CONDITIONS OF APPROVAL:

Engineering - Final Plat Checklist

Family Legacy PUD Subdivision, final plat (Life Celebration Center of Franklin) - submittal 002.pdf

4. C. Final Plat

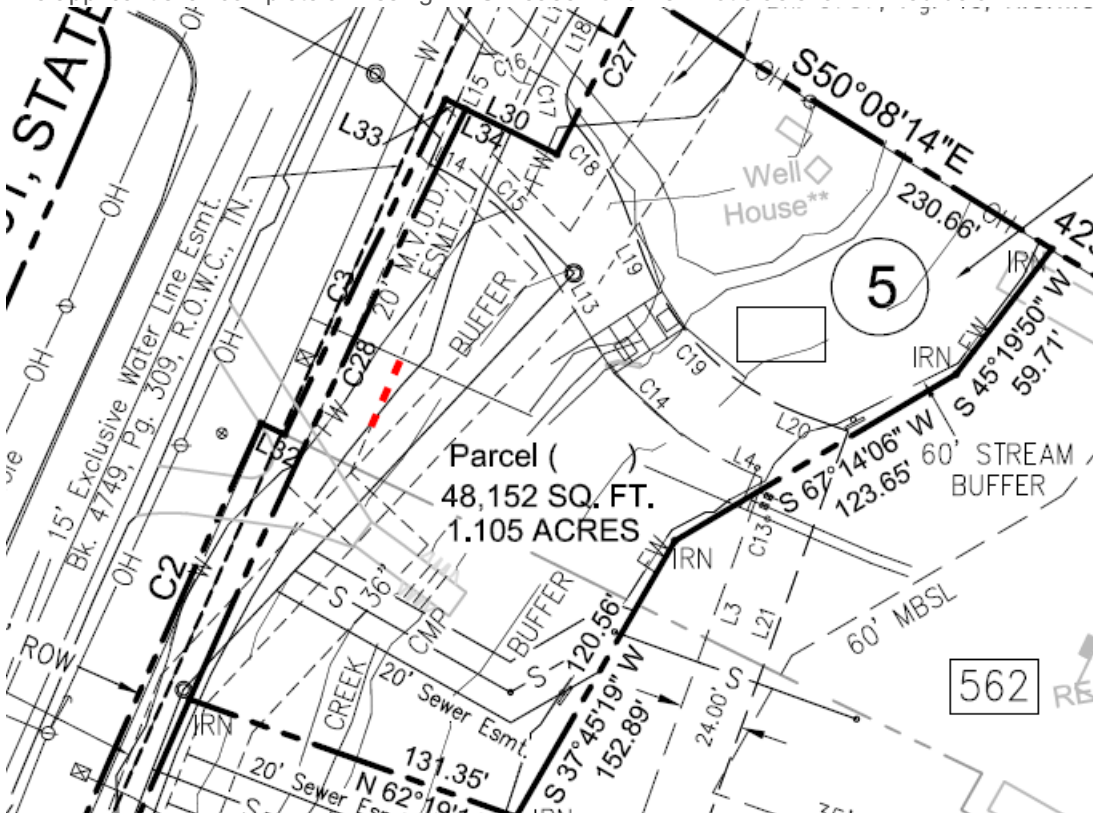
- Applicant shall indicate all existing and proposed easements associated with utilities. City of Franklin Easement Requirements (per Technical Specifications - General Design Requirements):

- 0-12' depth: 20' exclusive easement on center
- 12'-20' depth: 30' exclusive easement on center
- Depths greater than 20' require prior approval from Engineering/Water Management Departments

The applicant shall complete a missing MVUD easement line in lot 5 as shown in red below:
